Summary of Comments

A-2025-041, A-2025-042, A-2025-043, A-2025-044, A-2025-045 &
A-2025-046

946-950 Innisfil Beach Rd

COMMITTEE OF ADJUSTMENT MEMORANDUM

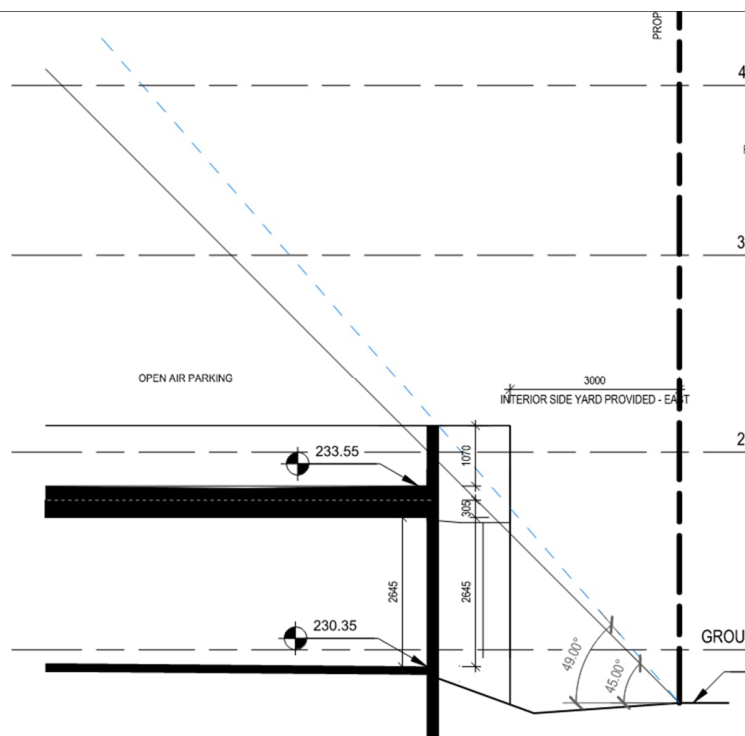
<p><i>implement the policies and strategies of this Plan to create Our Place.</i></p> <p>As per supporting documents listed under section 23.2 “Healthy Community Design Policy Statements for Official Plans - Simcoe and Muskoka District Health Unit -April 2014” Objective 2 highlights that <i>“Creating indoor and outdoor public spaces within a community that enables individuals to meet and congregate provides opportunities for social integration.”</i></p> <p>Based on the above, Staff are of the opinion that the proposed 0m² amenity space does not maintain the general intent and purpose of the Official Plan and would recommend deferral to engage in more discussion in this regard.</p>
<p>Maintains the purpose and intent of the Zoning By-law: <input checked="" type="checkbox"/> Yes <input type="checkbox"/> No</p>	<p>The subject lands are zoned Mixed Use 2 (MU2) Zone as outlined in the Town of Innisfil Zoning By-law No. 080-13, which permits mixed-use structures and associated parking areas. The surrounding neighbourhood is characterized by a mix of residential and commercial uses. The below variances are proposed to facilitate the development of a proposed eight (8) storey building containing 58 residential units and 195m² ground floor commercial space, mixed-use and associated parking and landscape areas.</p> <p>A-2025-041</p> <p>Table 5.2b C requires a minimum interior side yard setback of 7.5 m and subject to the 45 degree angular plane where the interior side yard abuts an R1 Zone. The intent of the regulation is to regulate massing and building height so as to not create negative impacts on the neighbouring low density properties, while ensuring adequate space for outdoor areas, landscaping, and maintenance access. The proposed parking structure is set back 3m from the eastern interior side lot line. The proposed upper level of the parking structure includes an architectural feature to buffer vehicular headlights from abutting properties. As a result, a minimal portion of this level extends beyond the 45° angular plane as per below drawing with a proposed 49 degrees. The setback reduction applies only to the open-air parking structure; the 8-storey mixed-use building does not abut the R1 Zone and is compliance with the side yard setback requirements. Appropriate buffering from neighbouring residential uses is proposed to mitigate privacy and visual massing impact.</p>

**A-2025-042**

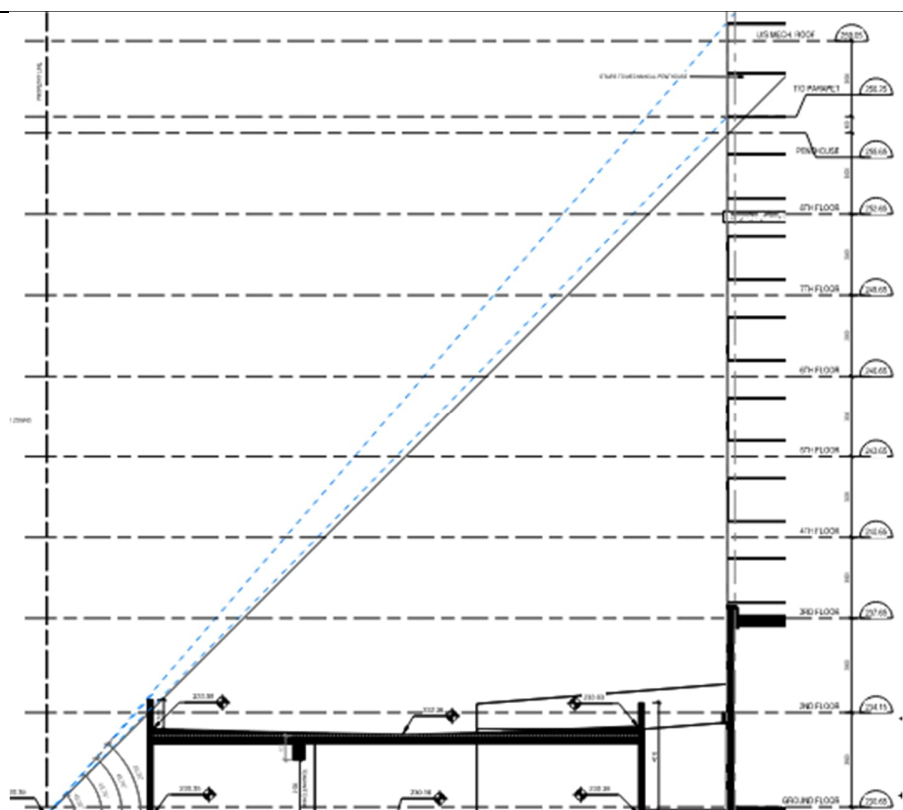
Table 5.2b E requires a minimum rear yard setback of 7.5 m and subject to the 45 degree angular plane. The proposed parking structure is set back 3.7m from the rear yard and the architectural feature encroaches into the 45 degree angular plane at 48.8 degree. Similar as the variance under A-2025-041, the proposed upper level of the parking structure includes an architectural feature to buffer vehicular headlights from abutting properties. As a result, a minimal portion of this level extends beyond the 45° angular plane as per below. The setback reduction applies only to the open-air parking structure; the 8-storey mixed-use building is compliance with the rear yard setback requirement. A 3m width landscape strip buffering from neighbouring residential uses is proposed to mitigate privacy and visual massing impact.

The proposed mixed-use building is set back 25.14 m from the rear lot line, well beyond the minimum 7.5 m requirement. The slight encroachment of the roof parapet into the 45° angular plane at 45.8° is considered minor and does not adversely affect adjacent properties at the rear yard. The building maintains sufficient separation to the rear lot line to mitigate overshadowing, privacy, visual massing and bulk impact.

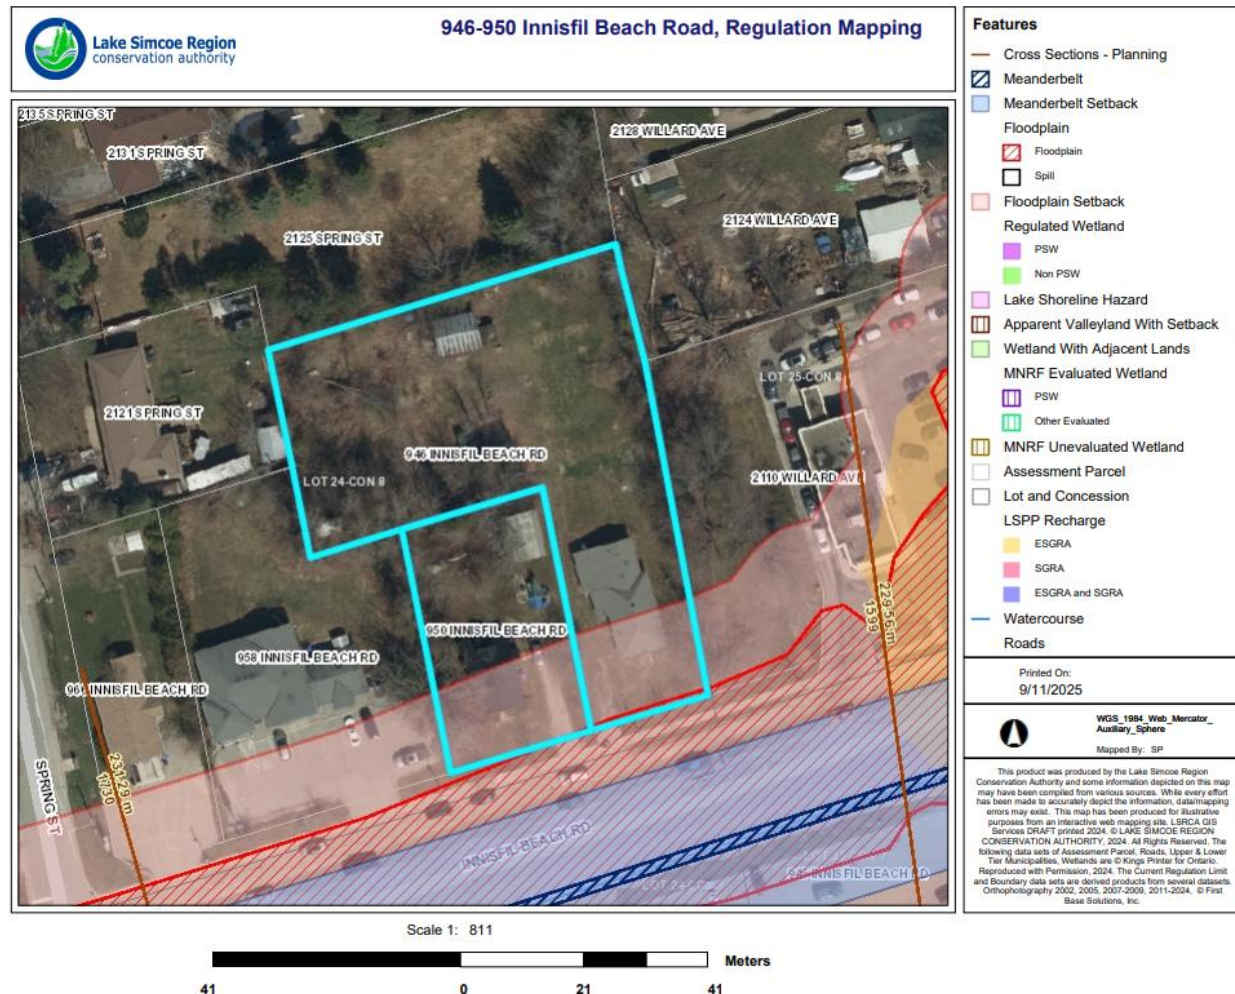
- The subject land is within the 'Mixed-Use 2 Zone' (MU2) as per the Town of Innisfil's Interactive mapping tool.
- The subject property is partially regulated by the LSRCA under Ontario Regulation 41/24 for Watercourse and associated flood hazards. Please see a detailed regulatory map below.
- The subject property is located within a completed watershed or sub-watershed study area – Innisfil Creeks Subwatershed Plan.
